ADDENDUM No. 1

UNION GROVE STATE PARK DESIGN GUIDE CABIN TAMA COUNTY, IOWA PROJECT NUMBER: 13-05-86-01

JULY 19, 2013

C3

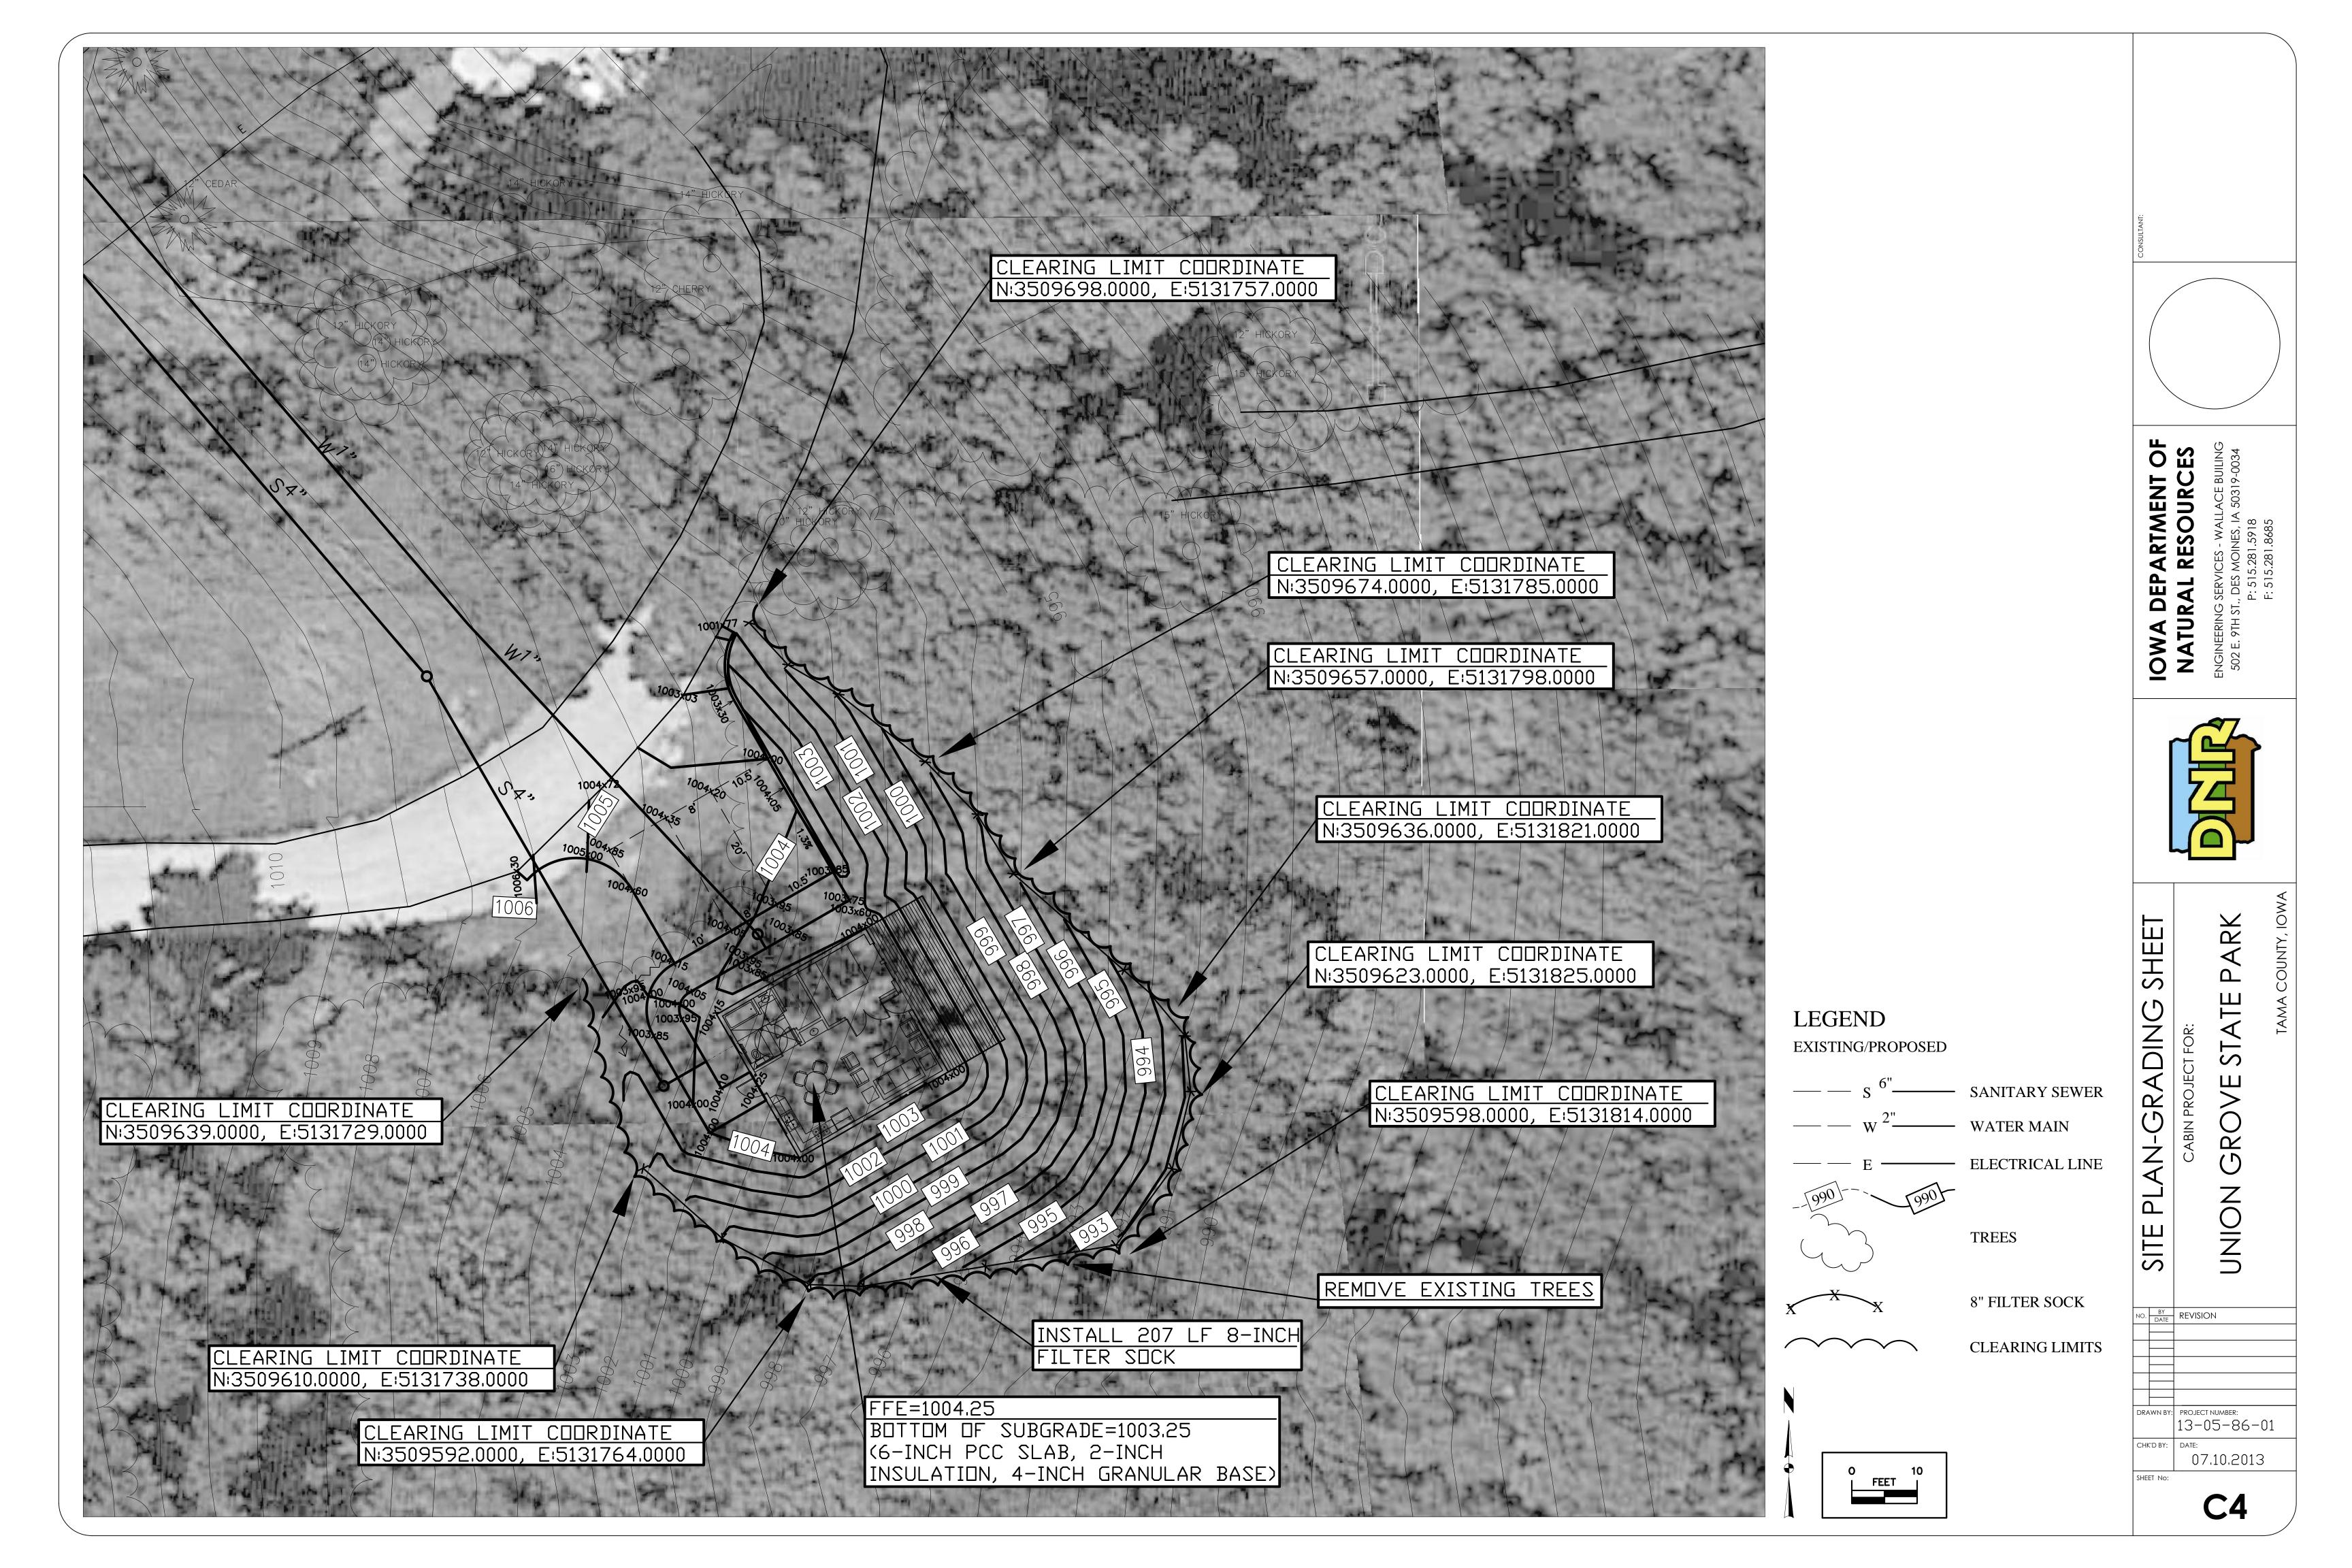
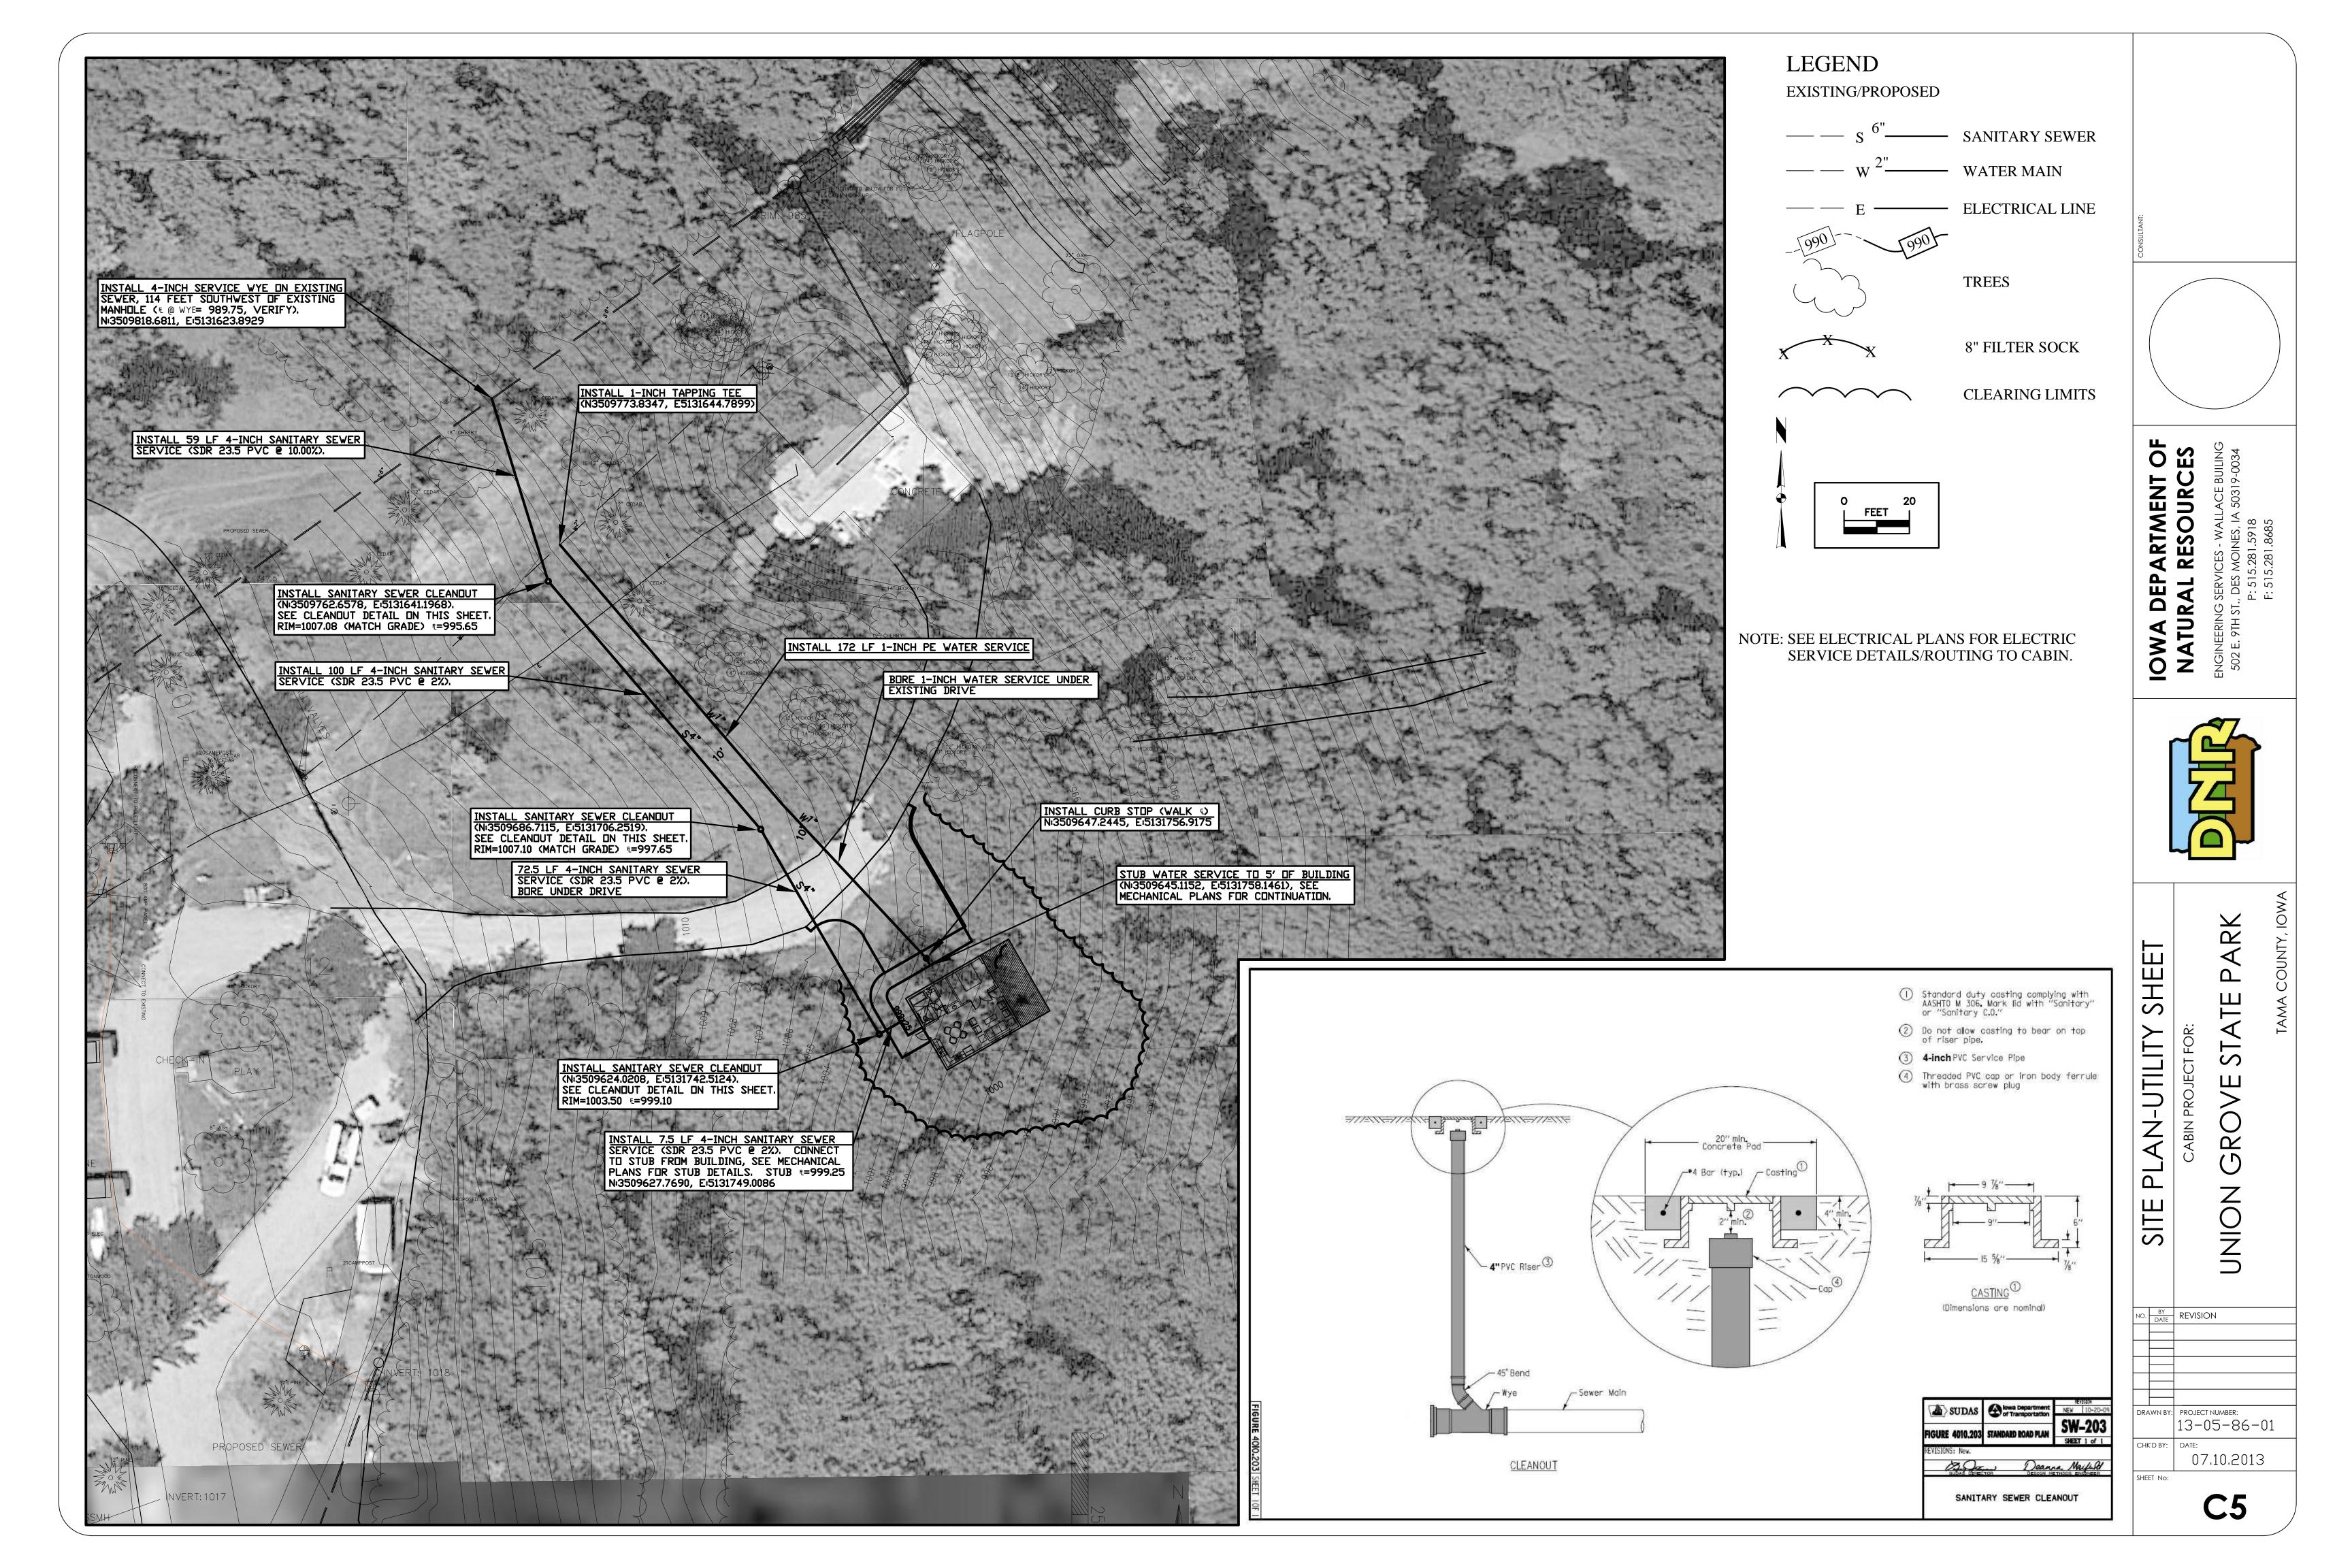
- 1. CIVIL PAGES C2 THROUGH C6 HAVE BEEN SUPERSEDED, PLEASE REFER TO THE ATTACHED NEW C2, C3, C4, C5 AND C6 PAGES AND REVISED QUANTITIES ON PROPOSAL SHEET ATTACHED.
- 2. DOOR 103 TO BE REPLACED WITH 4'-0" X 7'-0" SLIDING BARN DOOR AS SHOWN ON SK-1 ATTACHED.
- 3. HEAVY TIMBER TRUSSES TO BE ENGINEERED BY BUILDING SUPPLIER, PLEASE REFER TO SKETCH SK-2, ATTACHED FOR MORE INFORMATION. TRUSSES TO RECEIVE TWP 100 SERIES STAIN, COLOR TBD.
